Work Order ID 150741

Item ID: D3016-9 Accept ***N900040100*** Setup Start ***NS1***
Revision ID: Stop ***NS2***
Item Name: Saddle
Start Date: 8/31/2016 Start Qty: 10.00 ***10*** Cust Item ID:
Required Date: 9/7/2016 Req'd Qty: 10.00 ***10*** Customer:
Reference:

DESIGN <i>CP</i>	DRAWN BY <i>CP</i>	DART AEROSPACE LTD HAWKESBURY, ONTARIO, CANADA	
CHECKED <i>#</i>	APPROVED <i>#</i>	DRAWING NO. D3016	REV. A SHEET 1 OF 3
DATE 01.05.18		TITLE SEAT FRAME ASSEMBLY	SCALE NTS
A	01.05.18	NEW ISSUE

DRAWING NO. D3016	TITLE SEAT FRAME ASSEMBLY	REV. A	DART AEROSPACE LTD ENGINEERING ORDER	D.E.O. NO. D3016-A-1	SHEET NO. SHEET 1 OF 1	SCALE NTS
DRAWN <i>1</i>	CHECKED <i>UP</i>	MFG. APPR. <i>RE</i>	APPROVED <i>WAP</i>	DE APPR. <i>#</i>		
DATE 10.01.29	DATE 10.01.29	DATE 10.01.29	DATE 10.01.29	DATE 10.01.29

D3016-11 SADDLE

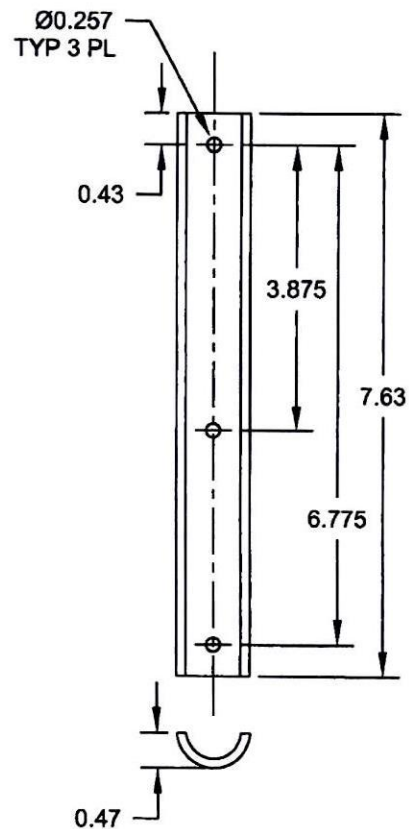
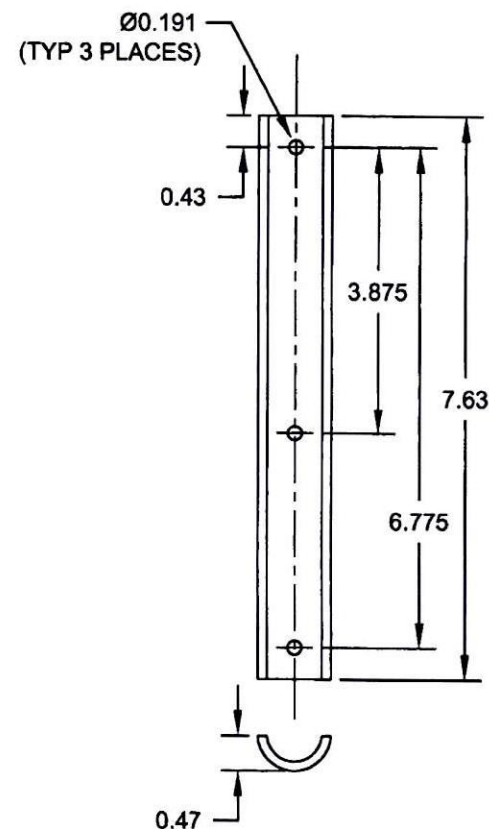
TO REVISE D3016-11 SADDLE'S HOLE SIZES

DETAIL D3016-11 SADDLE (SHEET 3): Ø0.257 TYP 3 PL WAS Ø0.191 (TYP 3 PLACES) AS SHOWN:
